SUBJECT: **ADDENDUM #1 TO THE BIDDING DOCUMENTS FOR:
NORTH HIGH SCHOOL BID GROUP#01**
NORTH AND SOUTH HIGH SCHOOL HVAC PROJECT 2022
COMMUNITY HIGH SCHOOL DISTRICT 99
NORTH HIGH SCHOOL
4436 MAIN STREET
DOWNERS GROVE, IL 60516
SOUTH HIGH SCHOOL
1436 NORFOLK STREET
DOWNERS GROVE, IL 60516

This addendum forms a part of the Bidding Contract Documents, dated November 30th, 2021. Bidders must acknowledge receipt of this Addendum in the space provided on the Bid Form.

- Mechanical Drawings:
MD2.02E.S;M2.02E.S;M5.02.S
- Electrical Drawings:
E2.02E.S; E2.04G.S; E2.04H.S;E3.00S; ED2.02E.S; ED2.04G.S; ED2.04H.S
- Question and Answer Log
- 004100 HVAC Scope
- 004101 HVAC Bid Form

ED2.02E.S

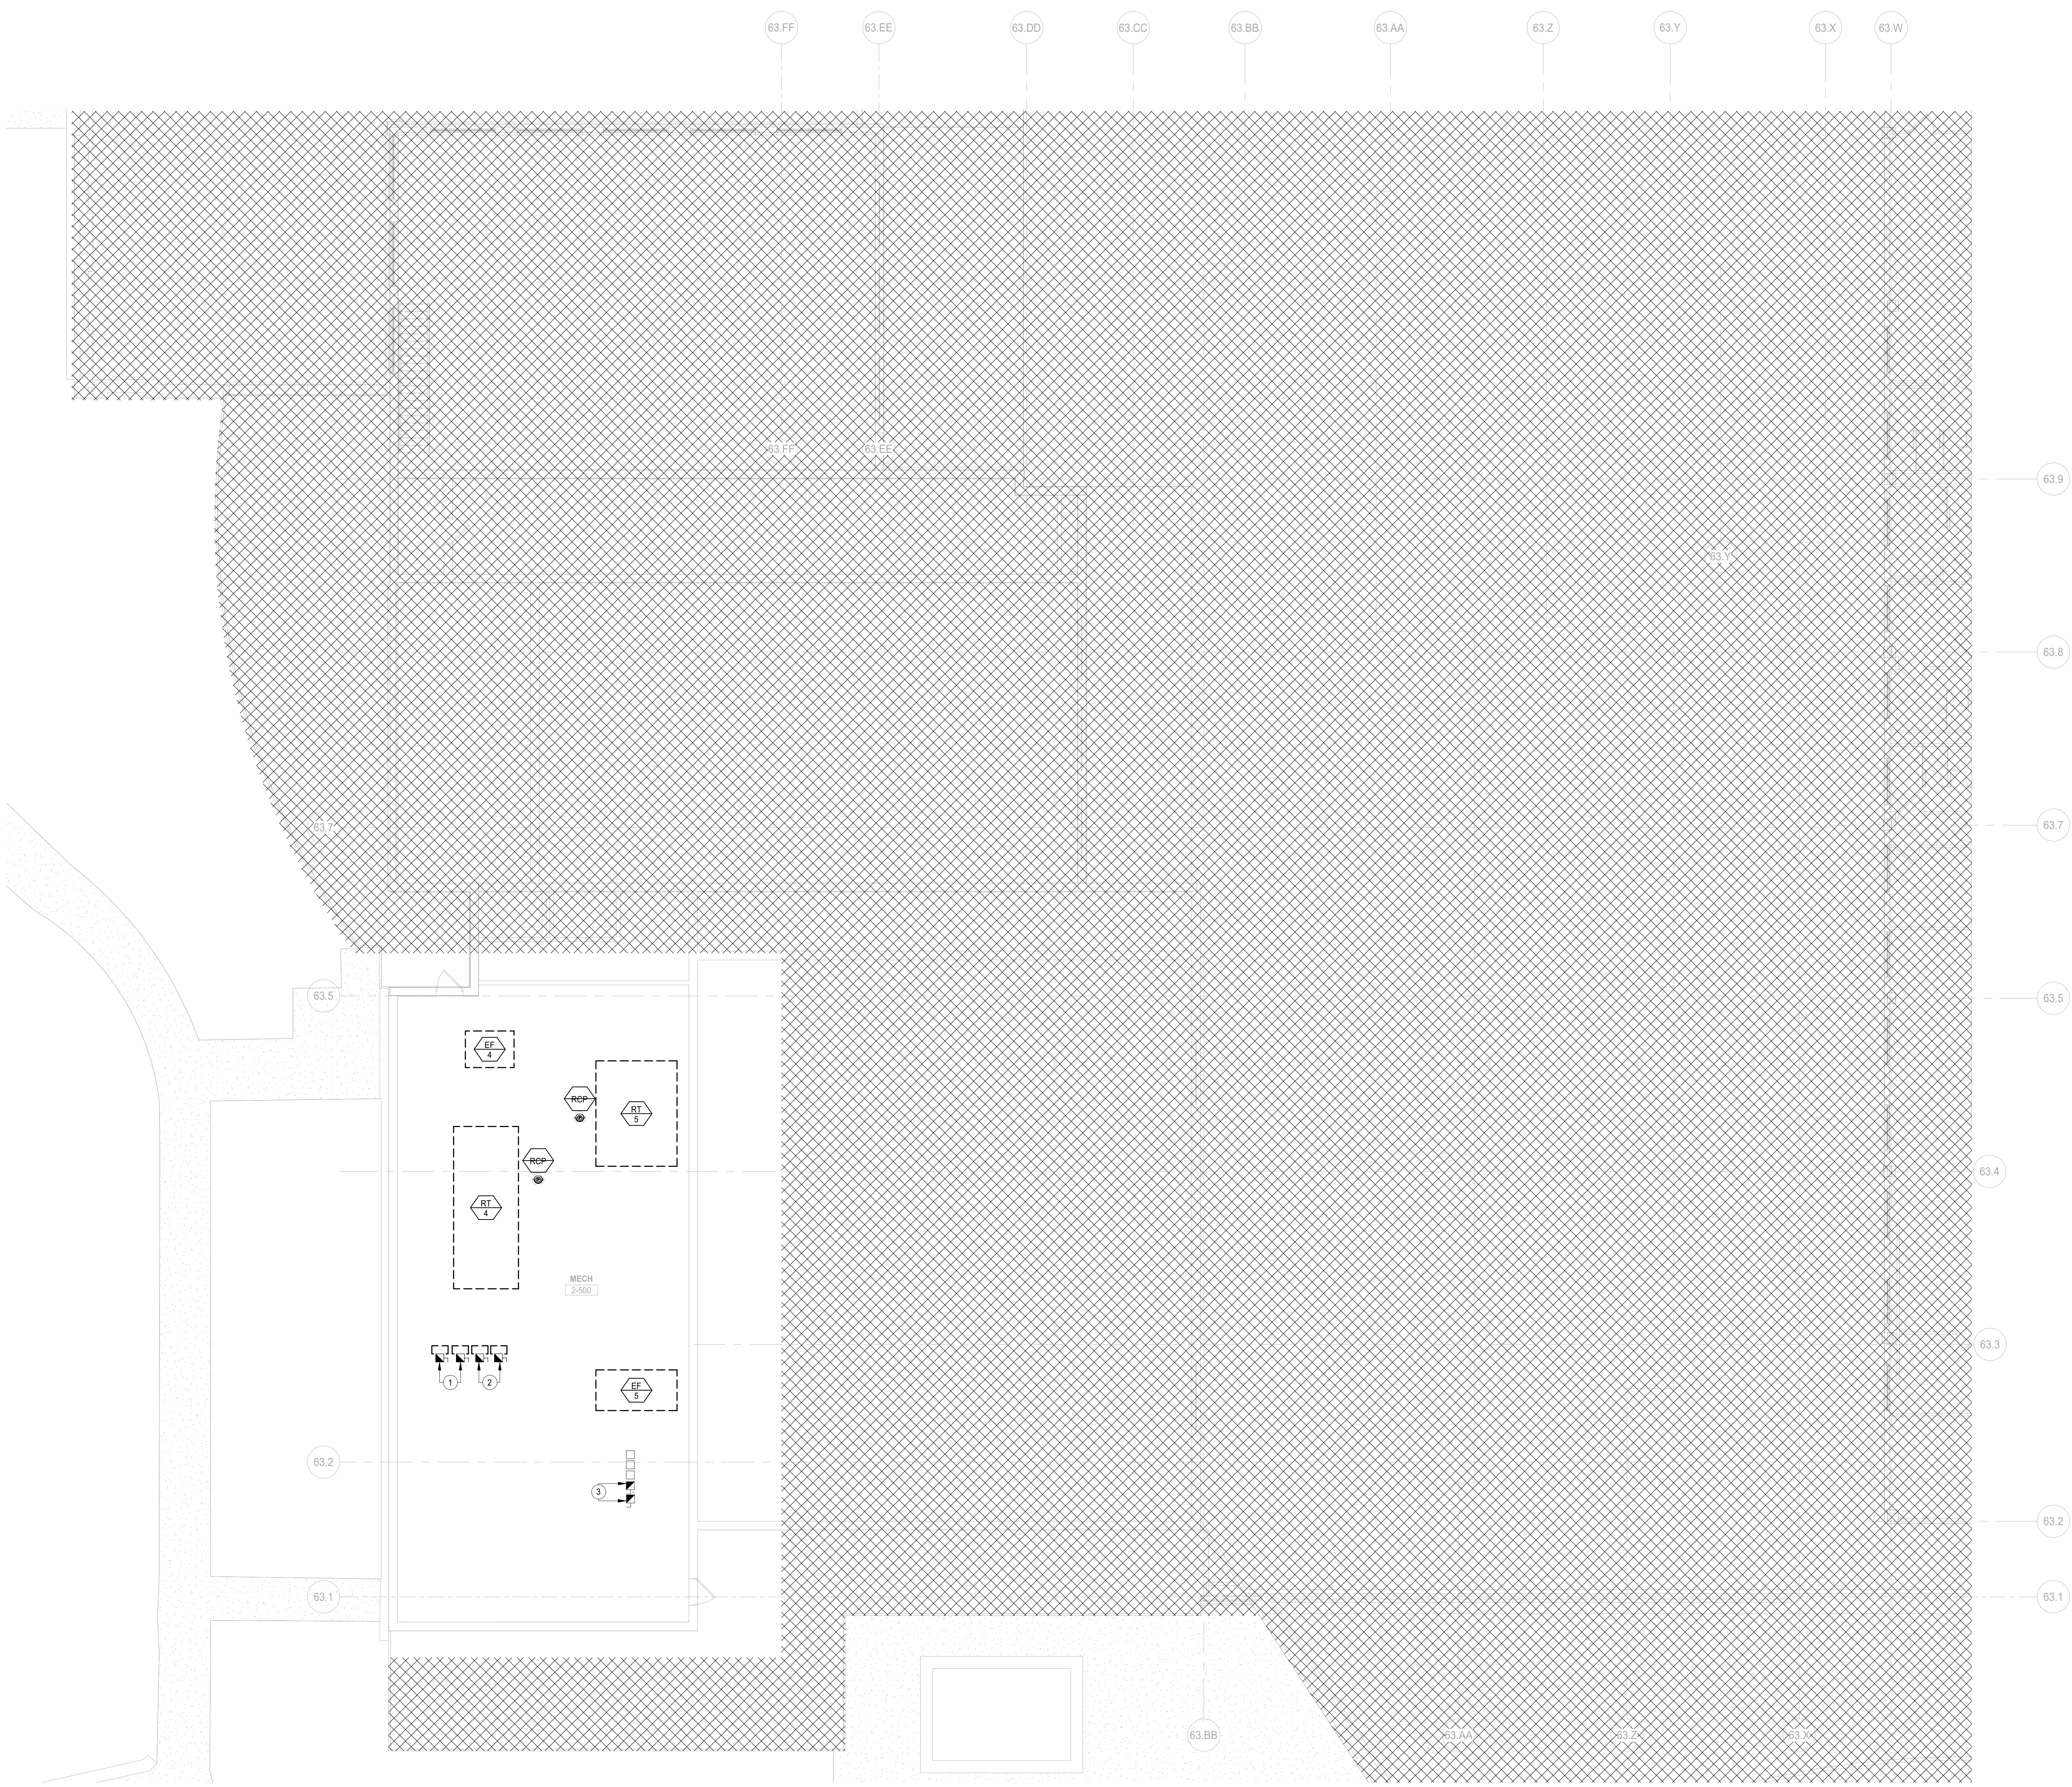
1. DISCONNECT AND REMOVE EXISTING DISCONNECTS SERVING THE EXISTING AHU UNITS. EXISTING CONDUCTORS AND CONDUITS SHALL BE UTILIZED FOR THE NEW UNITS PER THE NEW PLANS.
2. DISCONNECT AND REMOVE EXISTING DISCONNECTS SERVING THE EXISTING EXHAUST FANS. FALL BACK ALL CONDUCTORS AND CONDUITS TO THE SOURCE AND MARK AS SPARE. UPDATE PANELBOARD DIRECTORY AS REQUIRED.
3. EXISTING DISCONNECT SWITCHES SERVING THE EXISTING PUMPS SHALL REMAIN. DISCONNECT THE EXISTING PUMPS AND PREP FOR NEW PUMPS TO BE RECONNECTED PER THE NEW PLANS.

**ROOF LEVEL
DEMOLITION POWER
PLAN AREA G**

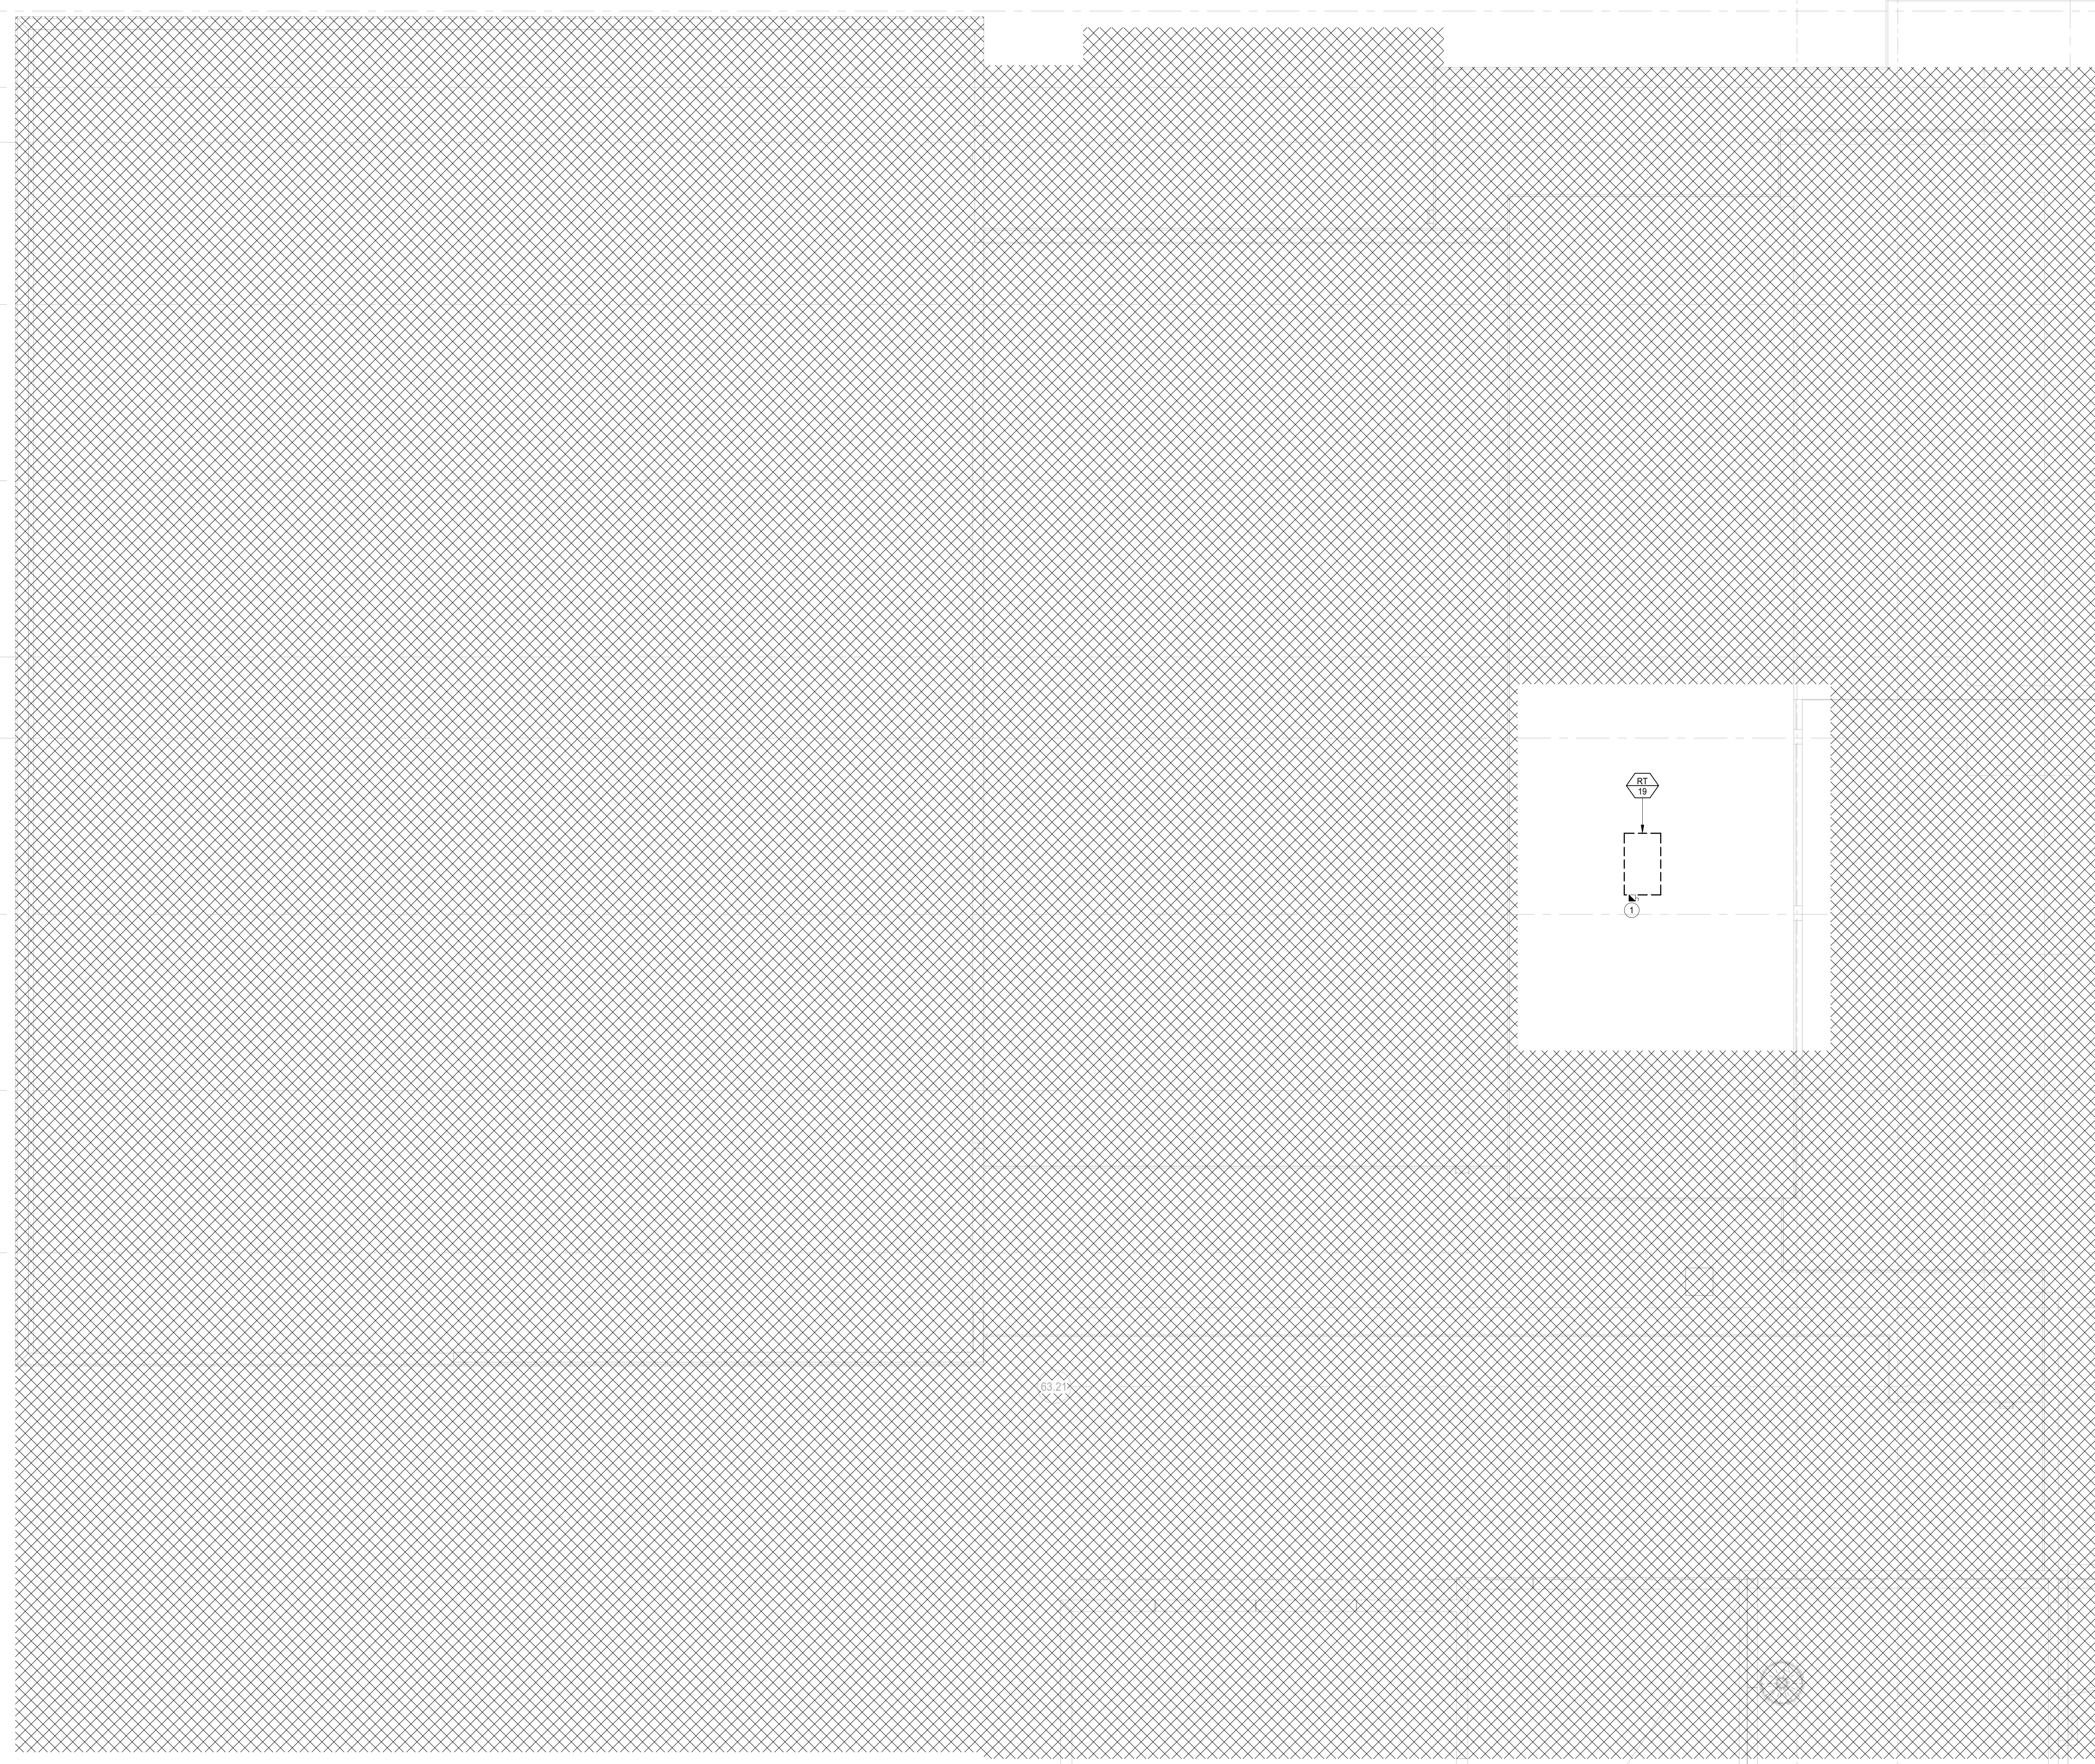
- DISCONNECT AND REMOVE EXISTING DISCONNECT SWITCH ON EXISTING RTU-19. EXISTING FEED TO REMAIN AND TO BE REUSED TO POWER THE NEW RTU-19 PER NEW PLANS. CAP AND PROTECT EXISTING FEED DURING CONSTRUCTION.
